Bulletin #4 of 2025. June 10, 2025

MAINTENANCE AND REPAIR BULLETIN

Port Insert Test Sheet

Products Affected: All fiberglass Kirby Morgan® helmets and both models of BandMasks®.

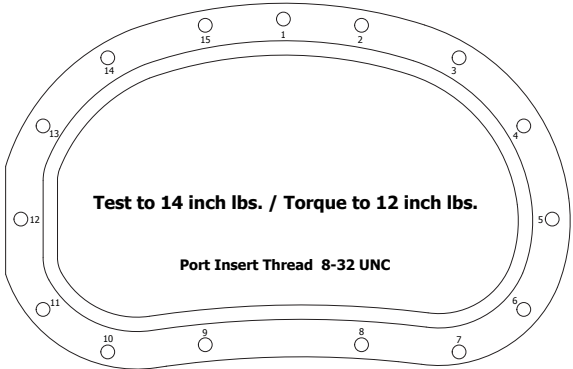
A2.1 Annual Inspection/Overhaul/Maintenance Checklist **MUST** include a signed and completed Port Insert Test Sheet. A2.1 Annual Inspection/Overhaul/Maintenance Checklists recorded without the Port Insert Test Sheet may be considered incomplete.

Testing of the Port Inserts should be conducted ONCE A YEAR, and/or whenever damage to the Port Insert is present or suspected, using KMDSI P/N 525-115, Thread Insert Testing Block Kit.

The test sheet also serves as the last page of the A2.1 Annual Inspection/Overhaul/Maintenance Checklist.
